## 2 Type of change

## 3 Detailed description of change

Product Change Notification					PCN Global Labeling		
owner	creation date	release date	released by	change order no	rev	page	D10-058-188
huberth	02.06.2021	02.06.2021	muehlema	2022100	C	1 of 2

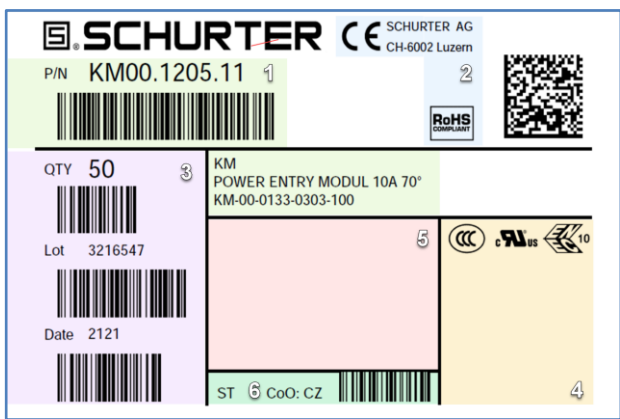
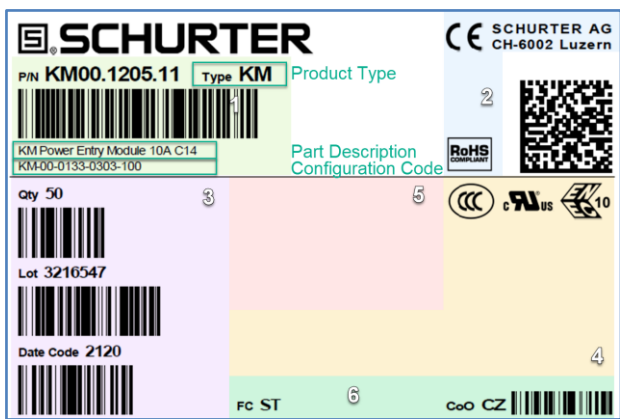
- Modified label
- Improved identification product configuration code on the label

All product types listed in section 1 receive a new label layout.

<b>Product identification section:</b> To improve readability, we clustered all the information concerning product identification in this group. To increase clarity, we introduce our product configuration code into this area.	1
<b>Product conformity section:</b> Identical information was slightly rearranged.	2
<b>Product logistics section:</b> Label names changed. Information was slightly rearranged.	3
<b>Product approval section:</b> Identical information was slightly rearranged.	4
<b>Interruption ratings section:</b> Identical information was slightly rearranged.	5
<b>Origin information section:</b> Label for Factory Code was added. Information was slightly rearranged.	6
